Road Safety Audit Report

**Incorporating
Stage 1 Completion of Preliminary Design;
Design Organisation Response to items raised; and
Auditors View of Design Organisation Response.**

Proposed Highway Access off the B3397 Hamble Lane Hamble-le-Rice

Report Title:	Stage 1 Road Safety Audit
Date:	December 2022
Document reference and revision:	RSA-22-158-4
Prepared by:	Fenley Road Safety Limited
On behalf of the Overseeing Organisation:	Hampshire County Council
Design Organisation:	i-Transport LLP
Project Sponsor:	CEMEX

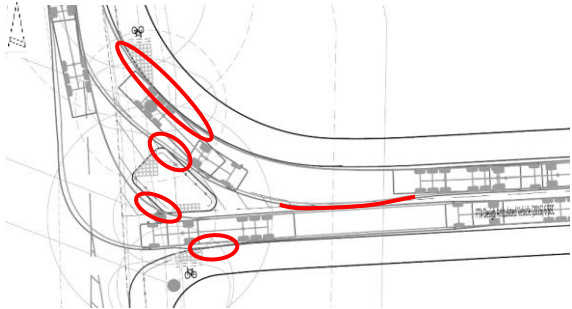
A.1	LOCAL ALIGNMENT
	<i>No Road Safety Concerns regarding LOCAL ALIGNMENT have been raised at this stage</i>
A.2	GENERAL
A.2.1	PROBLEM
Location:	Hamble Lane / Proposed access
Summary:	Geometric parameters do not allow for even a small deviation from the swept path illustrated
Acc Type:	Vehicle to pedestrian/ cyclist, loss of control, sideswipe type collisions
<p>Hamble Lane is a single carriageway road that accommodates a shared footway cycleway to the east which is level with but segregated from the carriageway by a grass verge that is approximately 1 metre wide. The proposals include the provision of a priority access off the eastern side of Hamble Lane which is to allow access to a minerals extraction site and accommodate an uncontrolled crossing point that benefits from a refuge island. Guardrailing is to be provided on the approaches to the crossing point to guide pedestrians and cyclists to the crossing point and deter users from crossing elsewhere. The Audit Brief details that the access is expected to observe 144 HGV movements throughout the day with peak of 26 in an hour. The scheme drawings illustrate the swept path of a 16.5 metre long articulated vehicle manoeuvring into and out of the proposed access, however, the wheel tracks as well as body of the vehicle appears to brush and encroach the kerb line with no margin for error or space for even a negligible deviation from the path illustrated particularly for the inbound movement. The Audit Team have concerns that a large vehicle deviating from the path illustrated, would encroach the proposed footway which could lead to a vehicle to pedestrians/cyclist collision, strike the proposed kerbing as well as guardrailing leading to a loss of control type collision or encroach the opposing lanes into the path of oncoming vehicles leading to sideswipe type collisions.</p>

RECOMMENDATION:	
It is recommended that geometric parameters are increased to ensure adequate space	
Location Plan:

<p>DESIGN ORGANISATION RESPONSE provided by i-Transport on the 2nd December '22 following formal issue of this Stage 1 Road Safety Audit on the 30th November '22.</p>	
<p>Swept path analysis has been undertaken for a 16.5m long articulated vehicle to demonstrate the 'worst case scenario'. It is however envisaged that the majority of HGV movements to / from the site will be undertaken by 20 tonne rigid vehicles (which have an approximate length of 10 metres) with larger articulated vehicles only observed on a rare occasion. Swept path analysis of the proposed access has been undertaken for a large tipper truck, as shown on drawing ITB13040-SK-013, which demonstrates that vehicles regularly anticipated to use the proposed site access junction can enter and egress the site safely.</p>	
<p>AUDITOR'S VIEW OF DESIGN ORGANISATION RESPONSE dated 2nd December '22</p>	
<p><i>Confirmation that the majority of vehicles that access the proposed minerals extraction site, will be 20 tonne rigid vehicles which can manoeuvre safely at the proposed junction and that articulated vehicles will not be regularly observed but can be accommodated, addresses the road safety concern at this stage.</i></p>

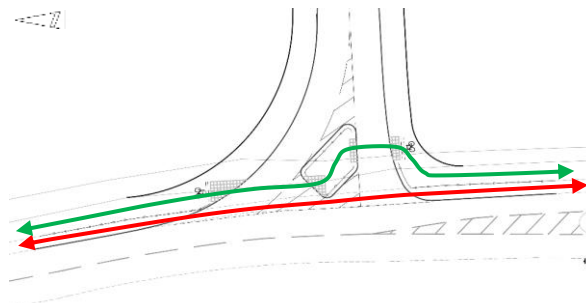
Summary: Pedestrians and cyclists are likely to travel along the existing verge

Acc Type: Vehicle to cyclist / pedestrian type collisions

Hamble Lane benefits from a shared footway cycleway along the eastern side of the carriageway that is offset from the carriageway by a one metre wide grass verge and allows access between The Hamble School to the north and Hamble-le-Rice to the south. As observed, the existing shared footway cycleway accommodates a high footfall particularly before and after the school day with users travelling along the grass verge as well as the footway cycleway. The proposals include the provision of a priority access off the eastern side of Hamble Lane. As part of the proposals, an uncontrolled crossing point is to be provided which benefits from a refuge island and guardrailling is to be installed to guide users towards the crossing point. It is though, however, that a number of pedestrians and cyclists will continue along the verge on the carriageway side of the guardrailling and attempt to cross the proposed junction along the edge of the Hamble Lane carriageway. Due to the seating position and eye height of a driver travelling in a Heavy Goods Vehicle, visibility in close proximity is very restricted and the Audit Team have concerns that a pedestrian or cyclist crossing in front of a Heavy Goods Vehicle will not be seen leading to a vehicle to cyclist / pedestrian collision.

It is recommended that the deterrent paving is installed within the verge besides the proposed guardrailling.

<p>DESIGN ORGANISATION RESPONSE provided by i-Transport on the 2nd December '22 following formal issue of this Stage 1 Road Safety Audit on the 30th November '22.</p>	
<p>Considered – There is potential to install deterrent paving to prevent the pedestrians and cyclists from using the verge and travelling on the wrong side of the pedestrian guard railing, if considered necessary by Hampshire County Council – the Local Highway Authority.</p>	
<p>AUDITOR'S VIEW OF DESIGN ORGANISATION RESPONSE dated 2nd December '22</p>	
<p>Confirmation that deterrent paving could be provided and will be further considered, addresses the road safety concern at this stage.</p>	
<p>A.5</p>	<p>TRAFFIC SIGNS, CARRIAGEWAY MARKINGS AND LIGHTING</p>
	<p><i>No Road Safety Concerns regarding TRAFFIC SIGNS, CARRIAGEWAY MARKINGS AND LIGHTING have been raised at this stage</i></p>

Item Location Plan

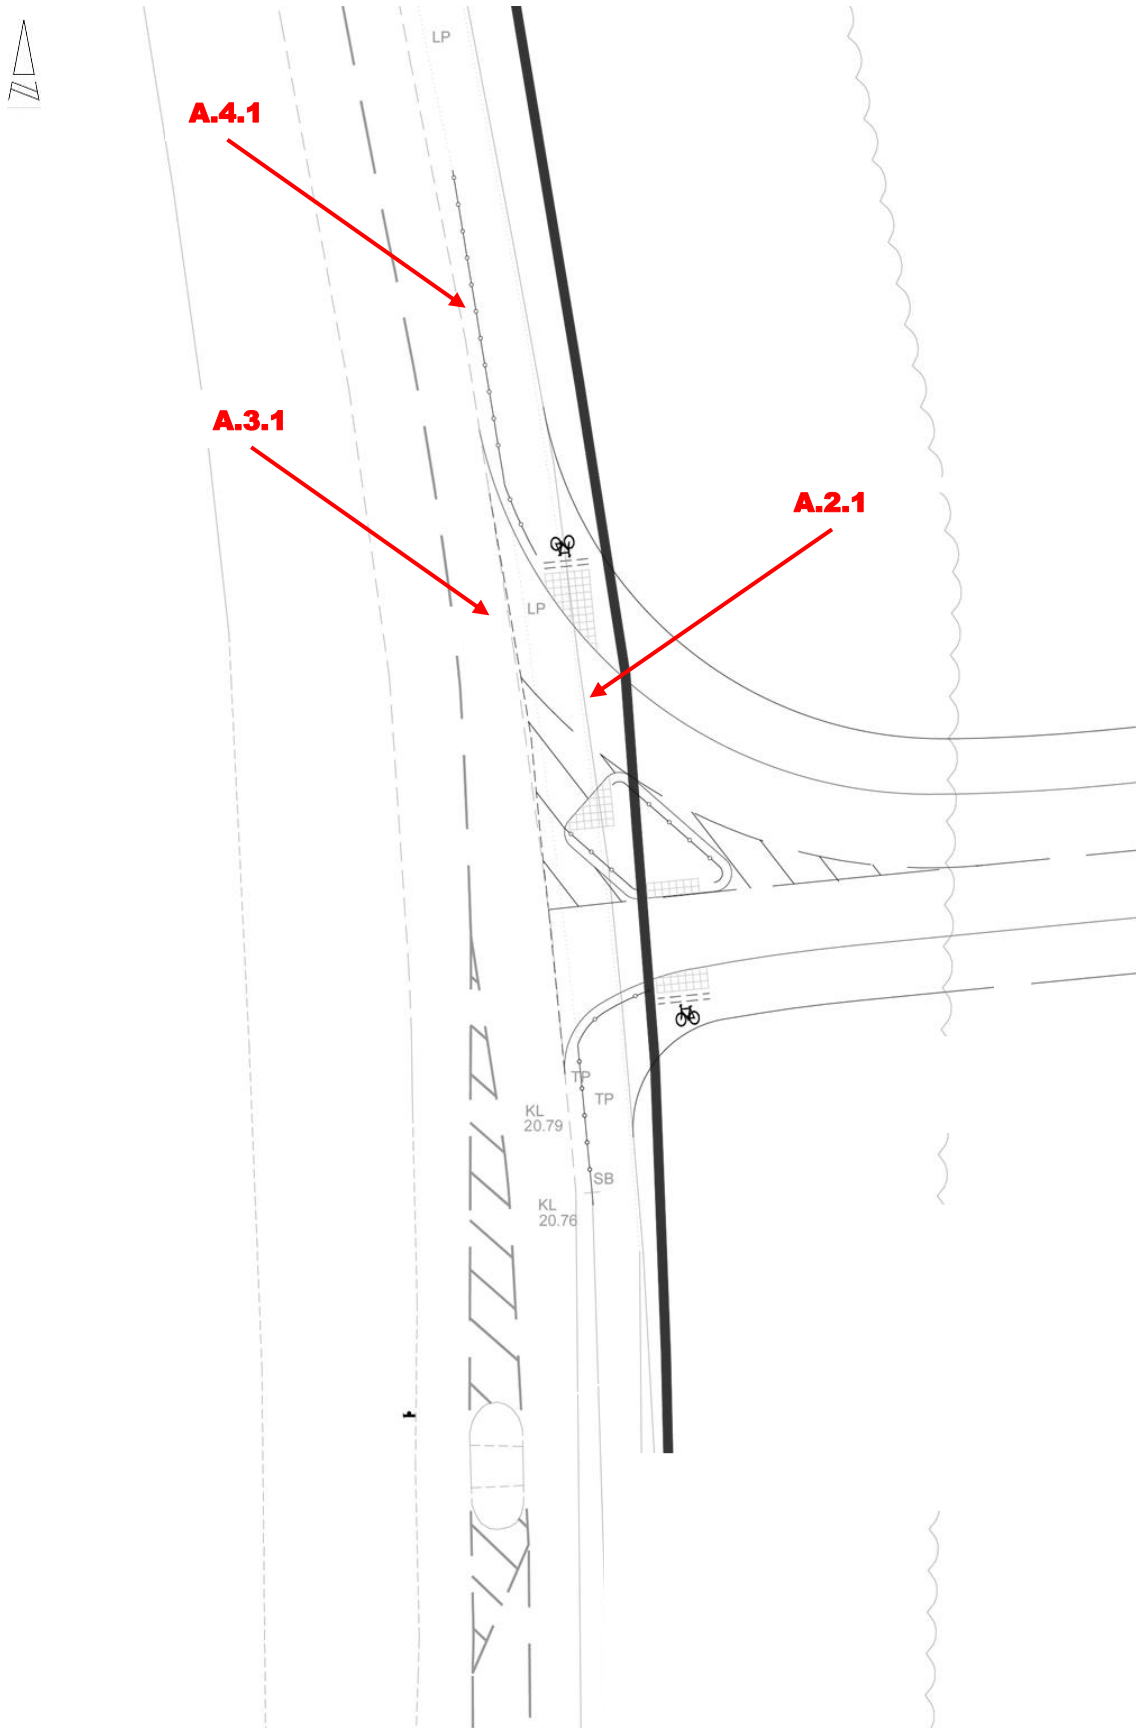
A.3	JUNCTIONS
A.3.1	PROBLEM
Location:	Hamble Lane
Summary:	Vehicles may be required to wait for some time to manoeuvre into the access
Acc Type:	Vehicle sideswipe / loss of control type collisions
<p>Hamble Lane is a single carriageway road that observes a traffic flow of circa 1,200 vehicles during the busiest hour and accommodates a shared footway cycleway to the east that allows access between Hamble-le-Rice and observes a footfall of circa 68 pedestrians as well as 26 cyclists during the period before and after the school day. Observations made during the first site visit undertaken, indicates that the footfall during these hours consists of groups of pupils spaced an estimated 5 to 10 metres apart that pass the site within a 5-minute period. The proposals include the provision of a priority access off the eastern side of Hamble Lane that benefits from an uncontrolled crossing and refuge island. Whilst the Audit Brief includes an assessment which details that the proposed priority junction will operate effectively and within capacity with design year traffic flows, the Audit Team is concerned that the updates to the highway code in recent years prioritise pedestrians and cyclists at priority accesses, will lead to the requirement for HGV's to wait within the Hamble Lane carriageway for some time. A stationary HGV waiting to turn left at a priority access could lead to traffic attempting to overtake as well as cyclists undertaking which could lead to vehicle sideswipe and HGV to cyclist type collisions.</p>

<p>RECOMMENDATION:</p>	
<p>It is recommended that the proposed crossing is relocated along the access road to allow adequate space for a HGV to exit the Hamble Lane carriageway before stopping to allow a pedestrian and</p>

cyclists to cross and that the proposed guardrailling is extended to the relocated crossing to prevent pedestrians and cyclists from crossing along the desire line.

DESIGN ORGANISATION RESPONSE provided by i-Transport on the 2nd December ‘22 following formal issue of this Stage 1 Road Safety Audit on the 30th November ‘22.

Considered – However, the latest version of the highway code, which states at Rule 170 and H2 that drivers should “give way to pedestrians crossing or waiting to cross a road into which or from which you are turning. If they have started to cross they have priority, so give way”. As such, it is expected that all drivers should now give way to pedestrians and cyclists crossing the side arm of junctions (whether new or existing) and therefore, other road users (such a car drivers following behind) should expect to wait for vehicles to give way. This is not limited to the proposed access arrangement and is the case for all new and existing priority junctions with crossing points. Moreover, it is noted that the traffic flows entering the site in the periods surrounding the beginning and the end of the school day are low. Between 08:00-09:00 it is anticipated that 6-10 HGV arrivals and 4-6 HGV arrivals between 15:00 – 16:00 across the different traffic phases of the proposed development, equating to on average one HGV movement every 6-10 minutes during the morning school peak and one HGV movement every 10-15 minutes in the afternoon. Therefore, there would not be frequent occurrences when vehicles had to wait if they arrived at the same time as pedestrians or cyclists are crossing the site access.

Consideration of relocating the pedestrian and cycle crossing further within the site (circa 20m) to allow a HGV to wait off Hamble Lane for pedestrians and cyclists to cross has been given. While this would be technically possible, it is considered contrary to prevailing pedestrian and cycle design guidance which states that “Designers should avoid layouts which make cyclists stop, slow down, or deviate unnecessarily from their desired route”. Furthermore, relocating the crossing point within the site limits pedestrian and cycle visibility splays to turning traffic and reduces the forward visibility of drivers to pedestrians and cyclists on approach to the junction.

It is understood that following the updated rules of the Highway Code, drivers / riders following traffic that is turning into a side road, should expect to wait behind a vehicle giving way to

pedestrians and cyclists, that the likelihood of a HGV arriving when school pupils pass is slim, and that relocating the crossing point away from the desire line is contrary to guidance on the design of cycle infrastructure detailed in LTN1/20, however, there is a risk as there is at the majority of junctions that observe HGV traffic.
